## Response to reviewer 1:

*“This manuscript concerns a new airborne radar-sounding dataset collected across Palmer Land along the southwestern coastline of the Antarctic Peninsula. The manuscript reports the motivation for collecting the dataset, the instrument used, visuals of the data collected and their overall significance. In this case, the bed topography near the grounding zone of multiple outlet glaciers is described in substantial detail, with its potential consequences for the future evolution of these glaciers carefully considered.”*

*“The manuscript by Winter et al. is a well written presentation of a new ice thickness data set covering nine ice streams and glaciers draining parts of Palmer Land on the Antarctic Peninsula into George VI Ice Shelf and Stange Ice Shelf, respectively directly into Bellingshausen Sea. The authors calculate the mass flux across the survey ice stream and glacier as show case for an application of the new ice thickness data set. The chosen structure is clear and the used data are easily accessible as described. Several suggested minor changes are given below.”*

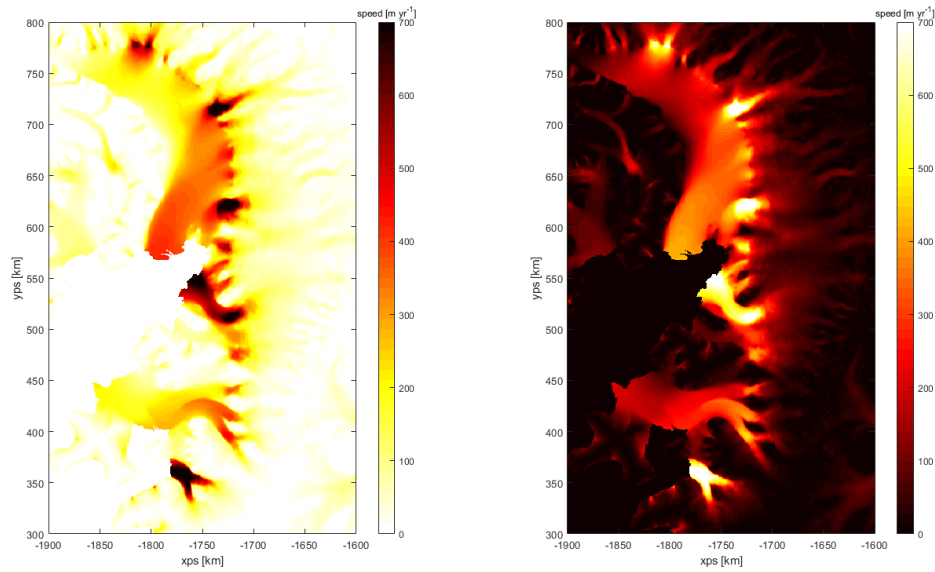
All figures except 2# (bed elevation) use a rainbow color scale (surface speed), whose future is bleak. I recommend switching to another color scale for longevity, e.g., "hot" in MATLAB. Further, given the spatial scales considered, I'm not getting much out of the continuous color bar. I strongly recommend switching to a discrete one ( $\sim 20$  intervals).

Thanks for your kind comments about our figures. We tried out the hot colour scale you suggested (see below), and we have tried other colour scales in a similar theme but we feel these lack the detailed information we present with our original colour scale so we have left the colour scale as it was in the original manuscript.

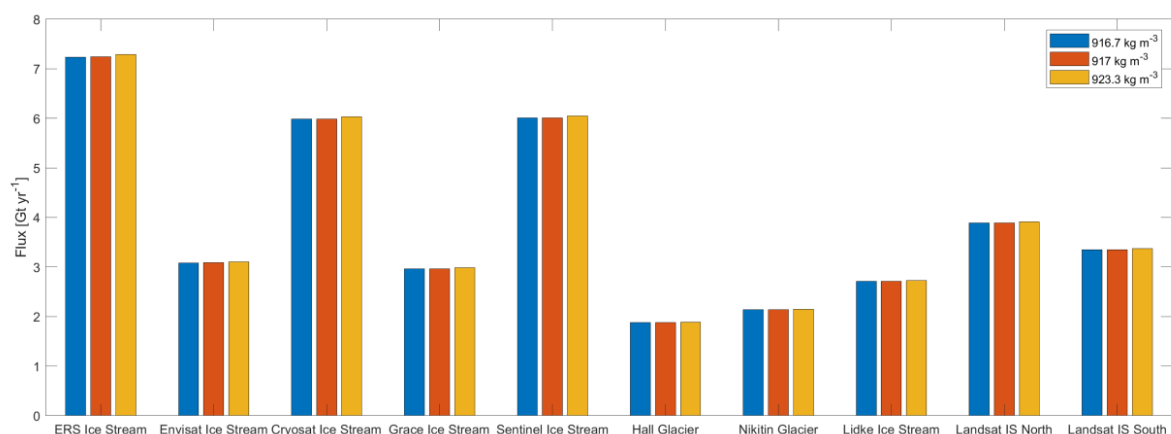
The wave propagation speed in ice (0.168 m/ns, L168) is in contradiction to the ice density (916,7 kg/m<sup>3</sup>, L 161) used for calculation of the ice fluxes. Using the equation given by Kovacz et al., 1995, the propagation speed should be 0.1684 m/ns (916,7 kg/m<sup>3</sup>), respectively the density 923,3 kg/m<sup>3</sup>. Why was a density of 916.7 kg/m<sup>3</sup> chosen?

Thank you for highlighting this discrepancy in ice density to us. We have explored the impact of density on flux outputs in the figure below. A density of 923.3kg m<sup>-3</sup> makes very limited difference to the flux outputs we present in the paper (less than 0.7% overall). Given that using a fixed value of ice density across each flux gate is already a simplification (which is ubiquitous to Antarctic geophysics), we do not believe that small differences in density value can introduce errors in our results.

Following comments from Reviewer 1, we realise that our original reference value for ice density of 916.7 kg m<sup>-3</sup> was perhaps too precise. Instead, for consistency and ease of comparison, we have chosen to use the ice density value of 917 kg m<sup>-3</sup>, which is utilised in both Bedmap2 and BedMachine - which are the main compilations used in continent wide flux gate and numerical modelling studies. We have now made this clear in the text presented in section 3.4.
